RE: Raptor Protection on New Power Poles and Soil Handling for
Pole Installation - Emery Mine

EMERY MINE
CONSOLIDATION COAL COMPANY
RAPTOR PROTECTION
ON A TYPICAL 8KV CLASS,
3 PHASE POWER POLE

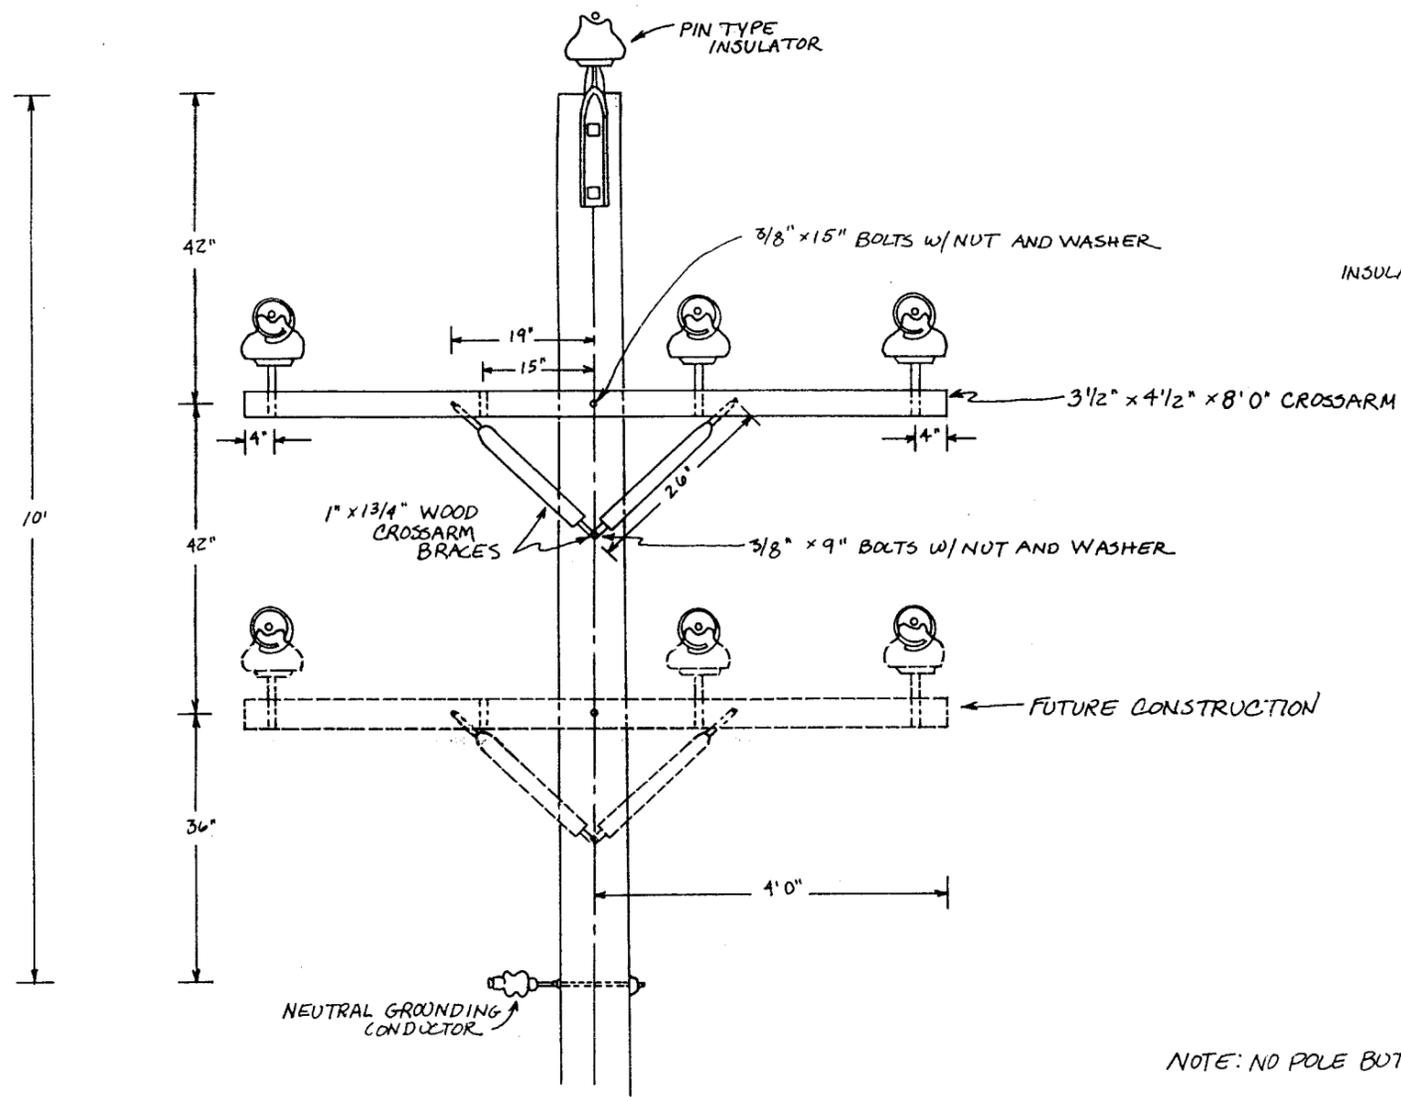
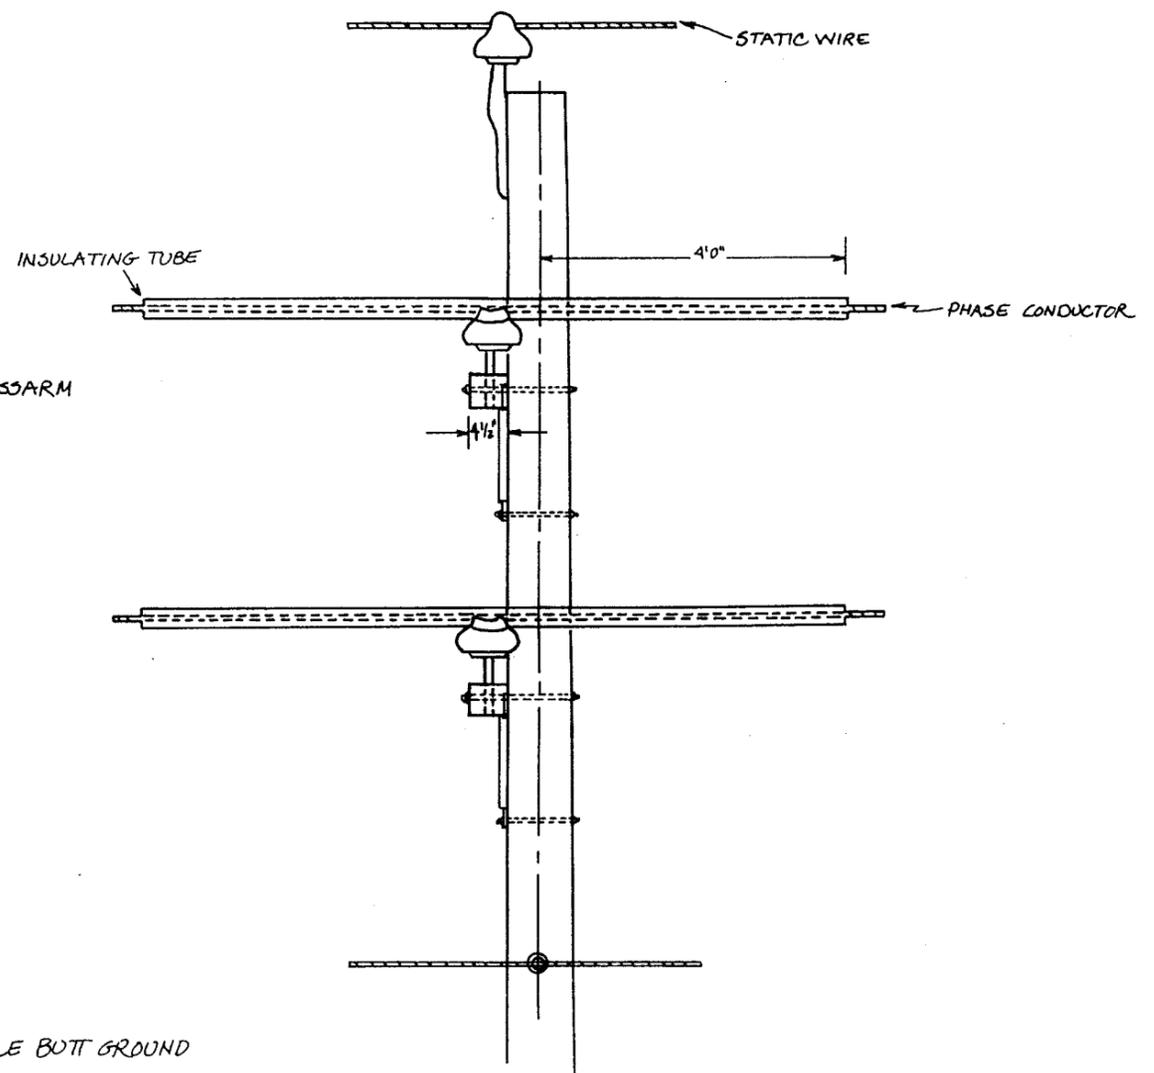
Instead of using a perch at the top of each pole as earlier submitted, an insulating tube will be placed around each phase conductor at each pole. A typical arrangement diagram is attached showing the proposed use of this insulating tube for this powerline.
